## **SOUTH WEBER CITY PLANNING COMMISSION AGENDA**

**PUBLIC NOTICE** is hereby given that the **Planning Commission of SOUTH WEBER CITY**, Utah, will meet in a **REGULAR** public meeting on **Thursday, April 13, 2017**, at the **South Weber City Council Chambers, 1600 East South Weber Drive**, commencing at **6:30 p.m.**

| 6:35 P.M. | <b>Public Hearing on Final Subdivision:</b> Application for Brimley Subdivision (2 lots) located at approx. 600 E. South Weber Dr. (Parcel 13-020-0056), approx. 0.85 acres, by applicant Grady Brimley |
| 7:05 P.M. | Old Maple Farms Subdivision Revised Preliminary and Revised Final Phases 1 & 2 (adding land drain system)   |

### **PLATS**

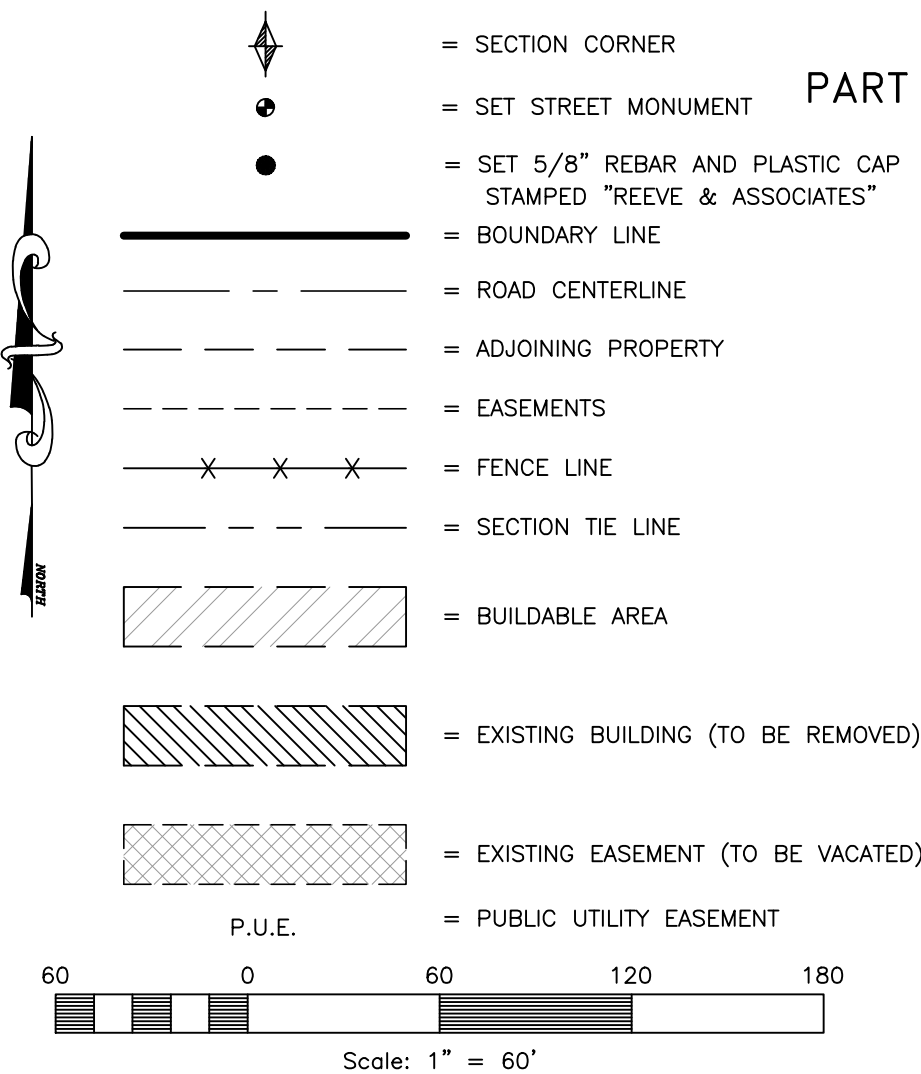
2. Note #2 on both plats needs to be changed to the following language:  
"R = Basements are allowed, but only to the maximum depth as shown in the "Basement Table." This depth represents the top of floor slab depth below top back of curb in feet, and also represents 18 inches from the top of floor slab to the land drain lateral invert. All homes must install a footing and foundation drain and connect to the land drain system provided in accordance with the recommendations of the geotechnical report."
3. The "Basement Table" needs to reference the lots as 101-R, 102-R, 201-R, etc.
